PEACEFUL RIDGE AT FOUNTAIN VALLEY SUBDIVISION

RESIDENTIAL SUBDIVISION CONSTRUCTION DRAWINGS

EPC STORMWATER REVIEW COMMENTS ARE SHOWN IN ORANGE BOXES WITH BLACK TEXT

PEACEFUL RIDGE AT FOUNTAIN VALLEY
MIRADOR LANE
PLAN AND PROFILE
EL PASO COUNTY, COLORADO

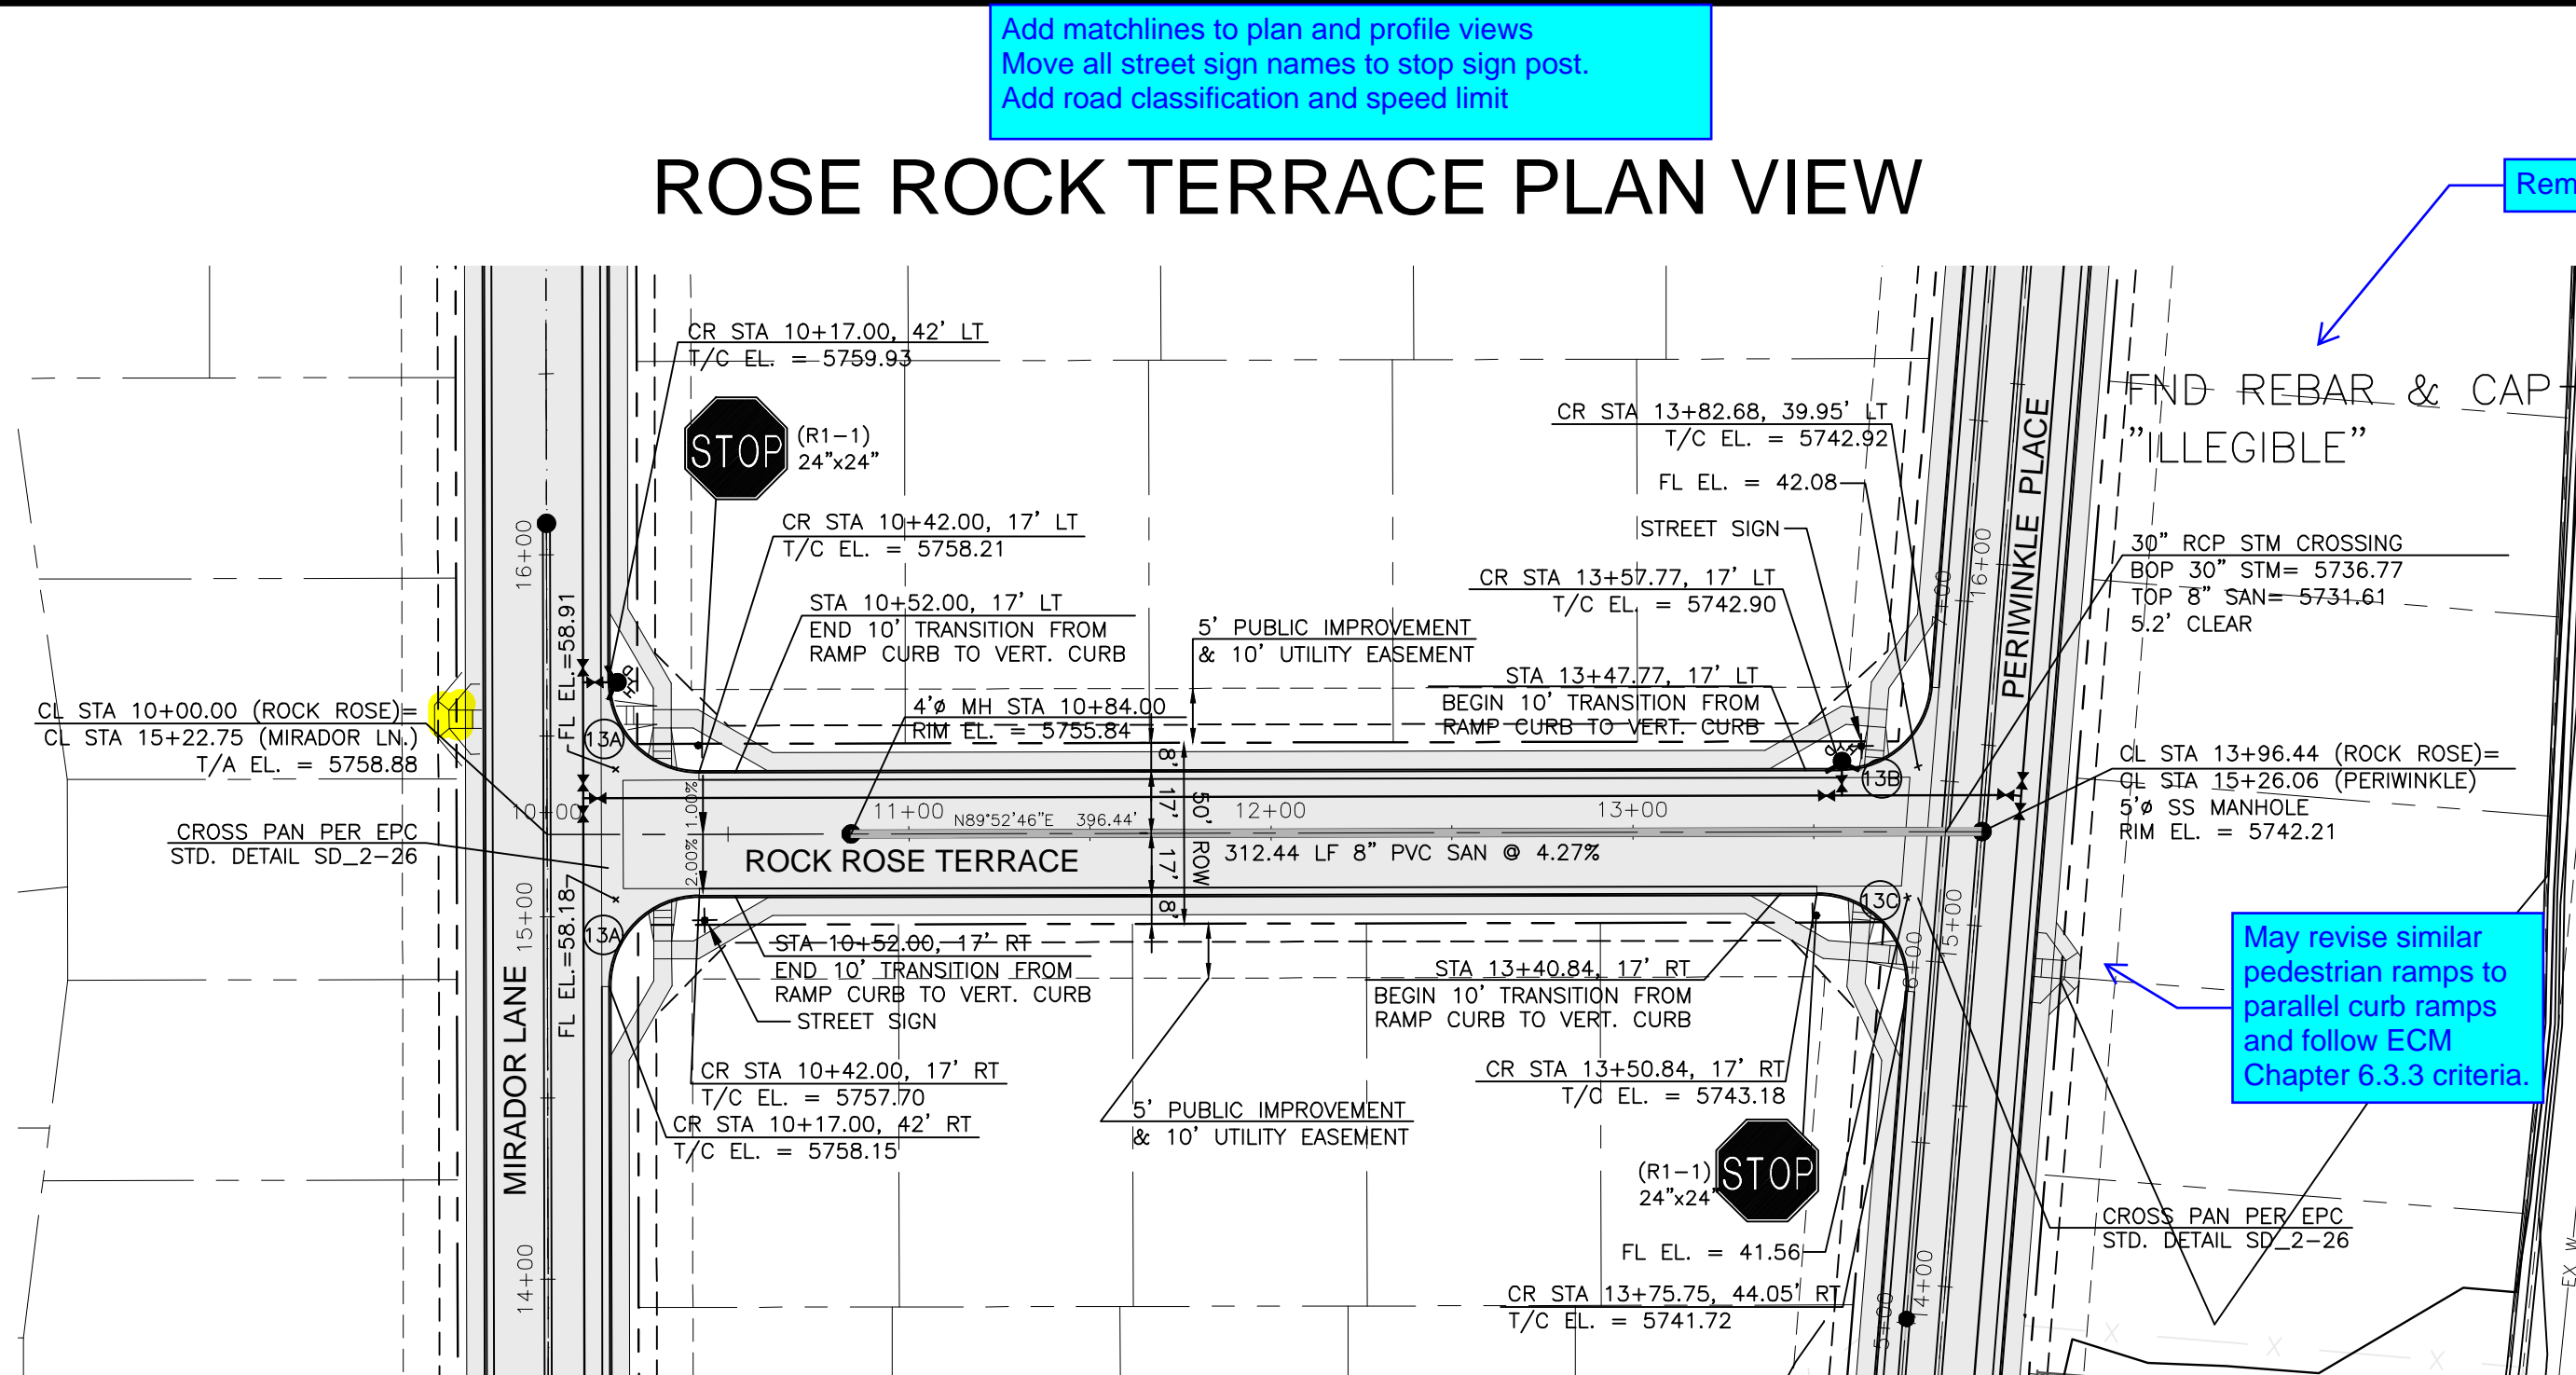
Align pedestrian ramp with the ramp across the street.
Recommend verifying ramp placement provides room for driveways.

PEACEFUL RIDGE AT FOUNTAIN VALLEY
PERIWINKLE PLACE
PLAN AND PROFILE
EL PASO COUNTY, COLORADO

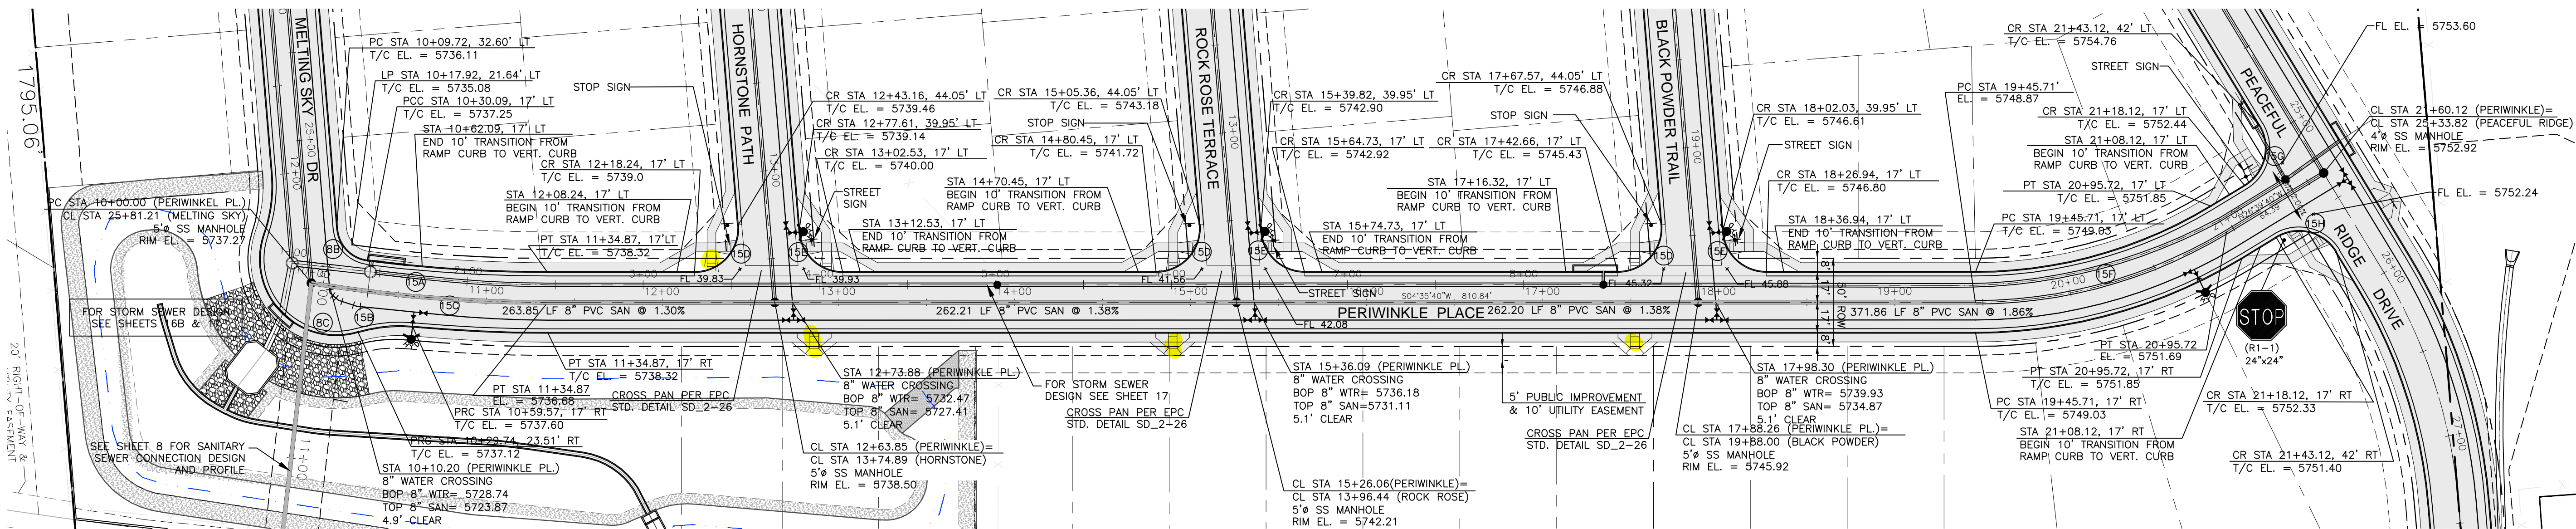
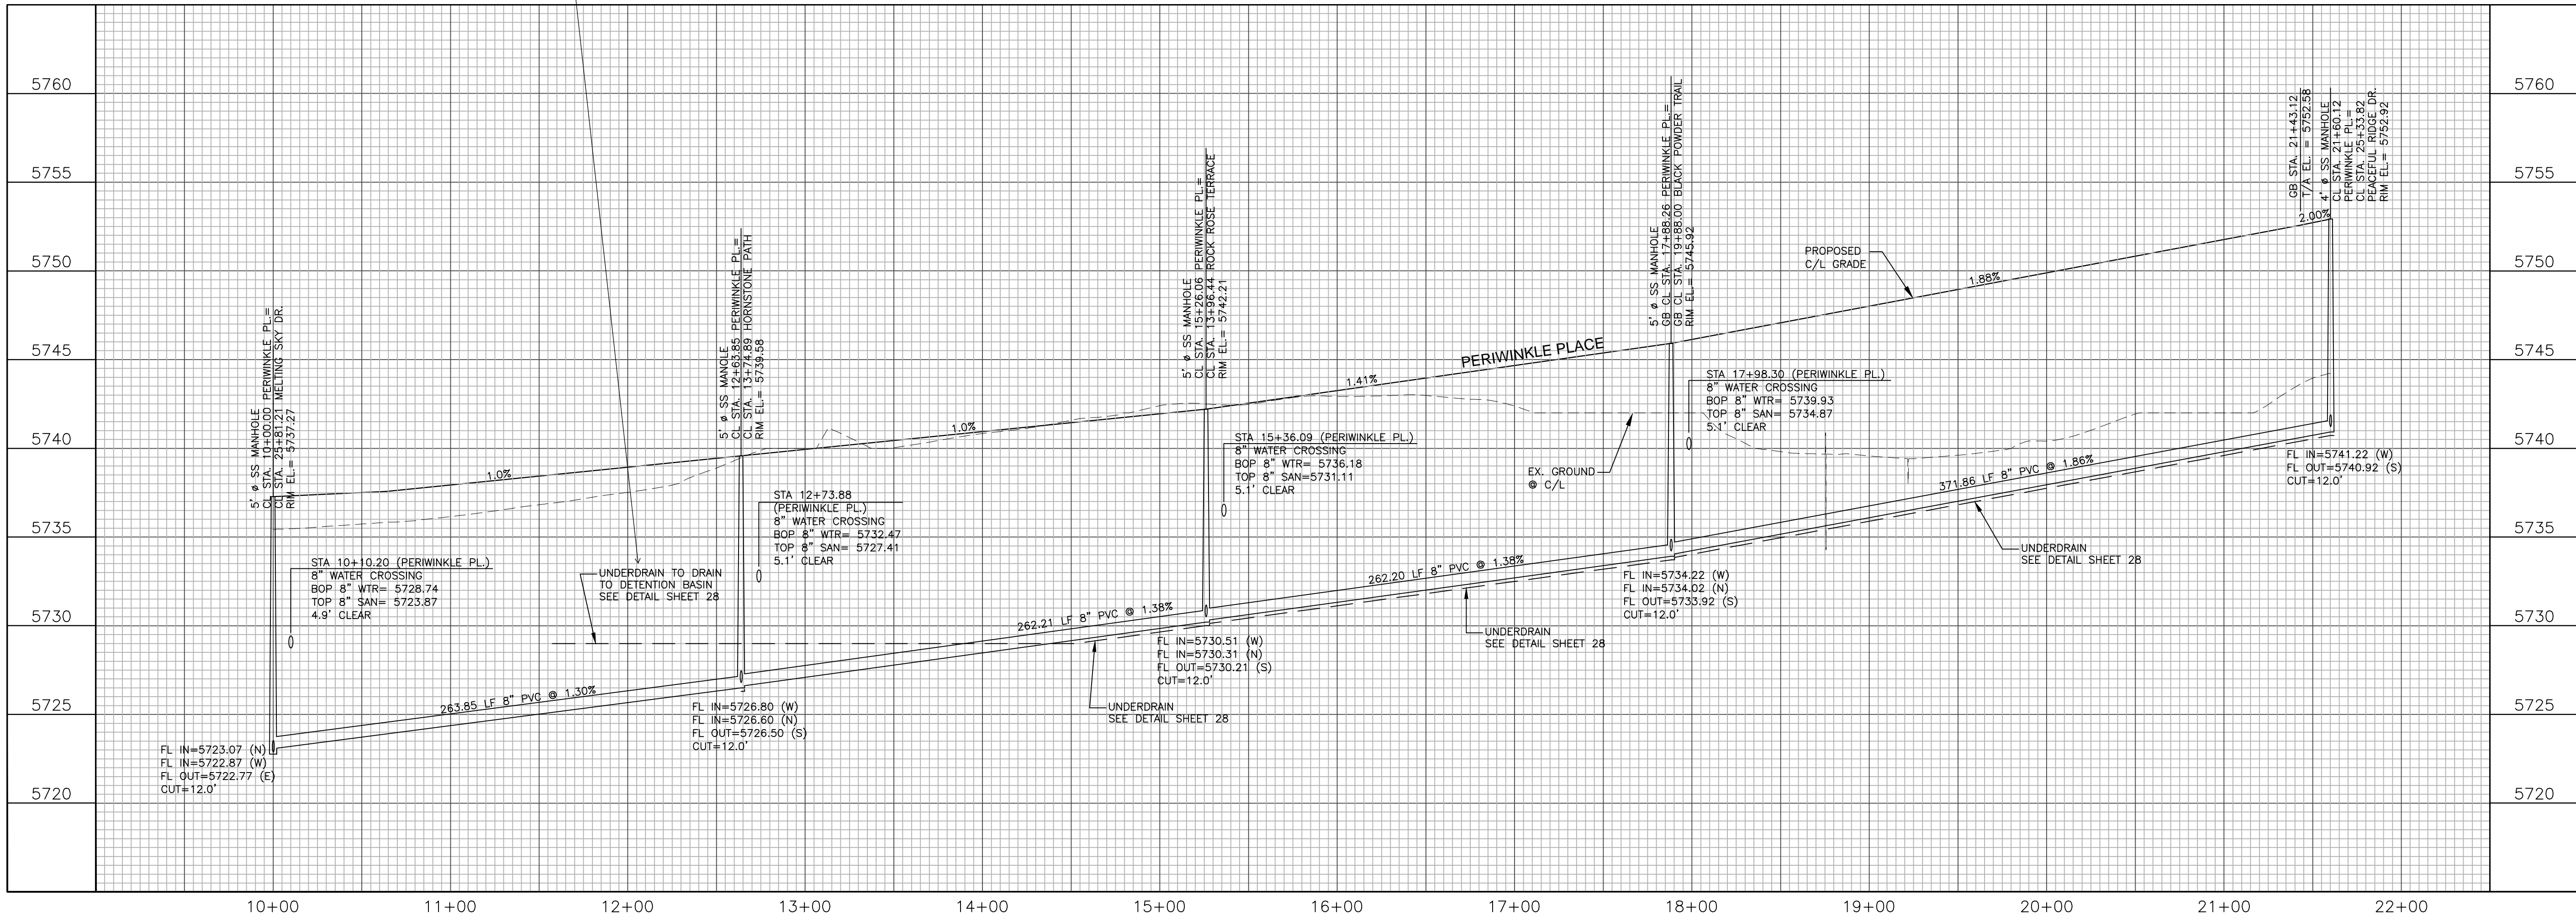
Max slope allowed at pedestrian access route intersections is 2%. Please revise.

Provide vertical curve data.

Add matchlines to plan and profile views.
Move all street sign names to stop sign post.
Add road classification and speed limit

what is the purpose of this underdrain (typ.) and do you plan on discharging into the EDB?

STORM SEWER D

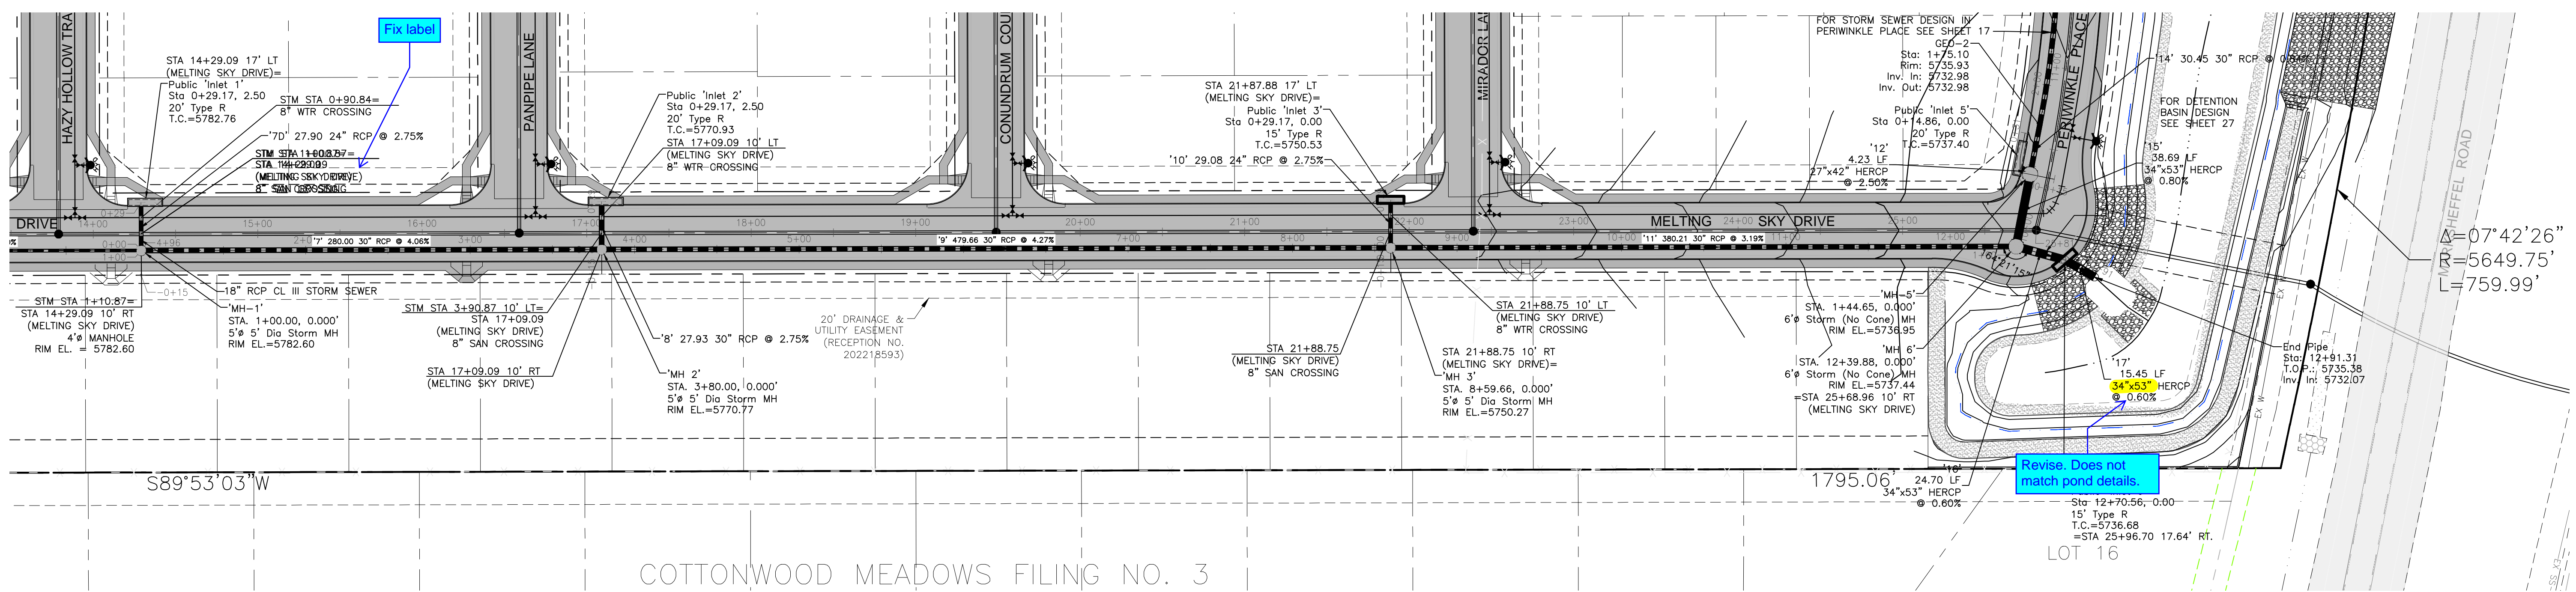
Label right-of-way/property lines and easements.

Label lot numbers

Label existing and finished grade centerlines.

Typical where all occurrences are present, a note stating water tight joints per ECM Chapter 3.3.1.D are provided will satisfy.

Add 100-year velocity (V100), label to pipe for public or private, and maximum and minimum cover checks. Verify all storm drain profiles have the information above.

STORM SEWER A PLAN VIEW

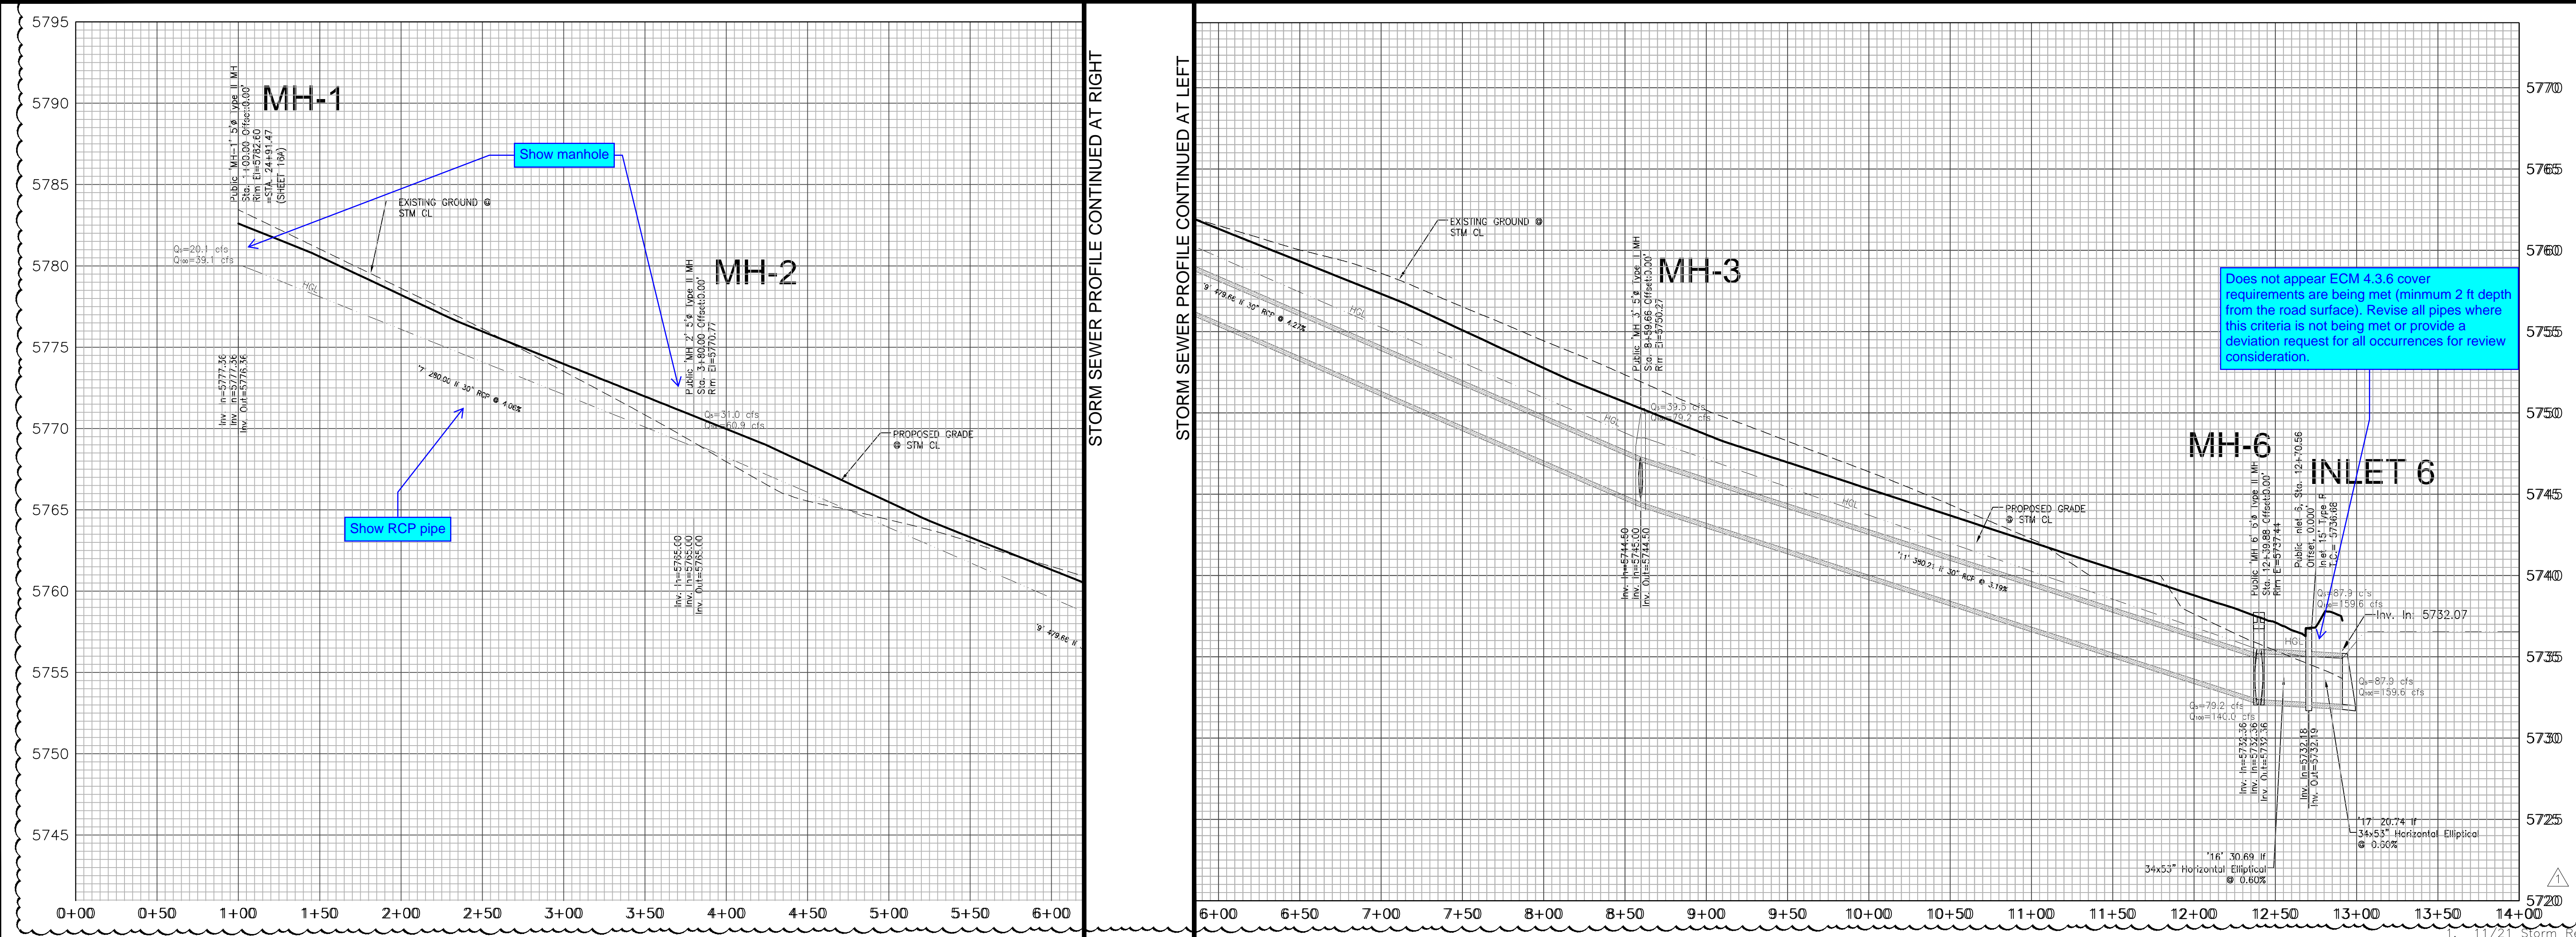
Provide radius at curve for the pipe for all typical occurrences.
